Project	IEEE 802.16 Broadband Wireless Access Working Group < http://ieee802.org/16 >	
Title	MS Identity Privacy in 802.16m	
Date Submitted	2009-1-5	
Source(s)	Haihong Zheng, Shashikant Maheshwari, Yousuf Saifullah	Haihong.Zheng@nsn.com
	NSN Jan Suumaki	jan.suumaki@nokia.com
	Nokia	
Re:	TGm SDD: 10.6.2.1 AMS Privacy	
Abstract	Propose temporary station identifier to support MS identity privacy	
Purpose	For discussion and adoption in 802.16m SDD	
Notice	<i>This document does not represent the agreed views of the IEEE 802.16 Working Group or any of its subgroups. It represents only the views of the participants listed in the "Source(s)" field above. It is offered as a basis for discussion. It is not binding on the contributor(s), who reserve(s) the right to add, amend or withdraw material contained herein.</i>	
Release	The contributor grants a free, irrevocable license to the IEEE to incorporate material contained in this contribution, and any modifications thereof, in the creation of an IEEE Standards publication; to copyright in the IEEE's name any IEEE Standards publication even though it may include portions of this contribution; and at the IEEE's sole discretion to permit others

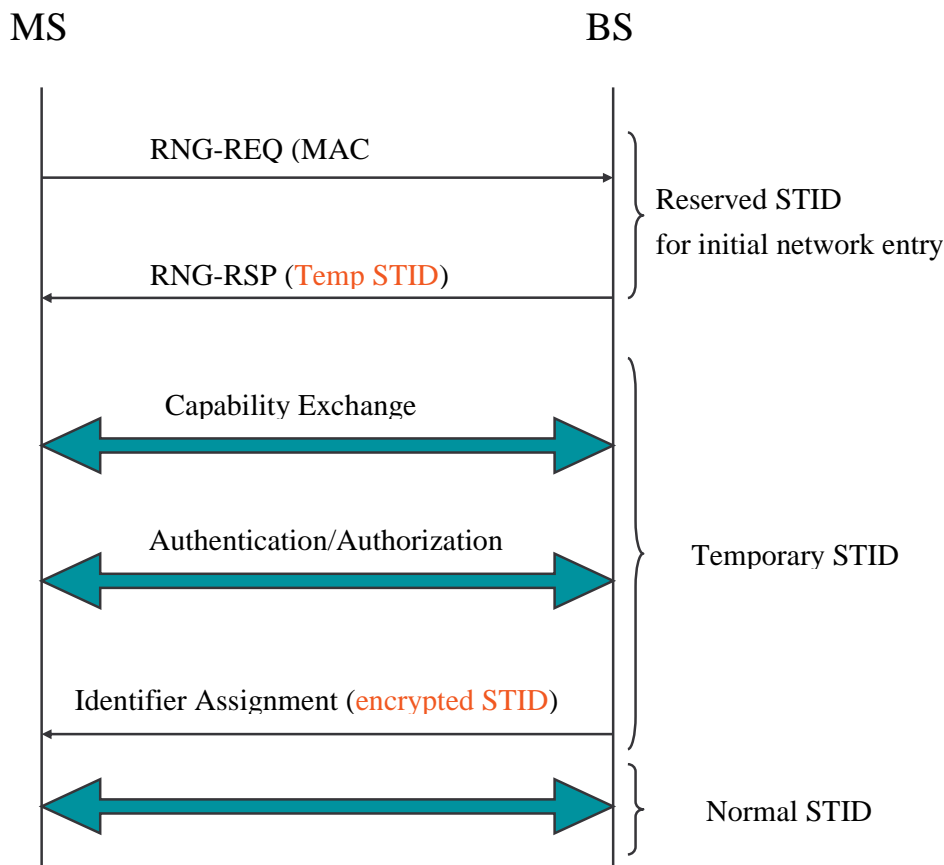
In order to solve the problem above, a Temporary Station Identifier (STID) is assigned during initial ranging process. After being assigned, it is used for the subsequent network entry procedures until the normal STID is allocated. Normal STID is assigned during/after authentication process, and the assignment message shall be encrypted. The temporary STID is then released and normal STID is used for all the remaining transactions. The detailed procedure is illustrated in the following figure.

In order to protect the mapping between the STID and the AMS MAC Address, two types of station identifiers are assigned to an AMS during network entry - temporary STID (TSTID) and (normal) STID. A TSTID is assigned during initial ranging process, and is used until the STID is allocated. The STID is assigned during the authentication process, and the assignment message is encrypted. The TSTID is released after STID is assigned. The STID is used for all the remaining transactions.
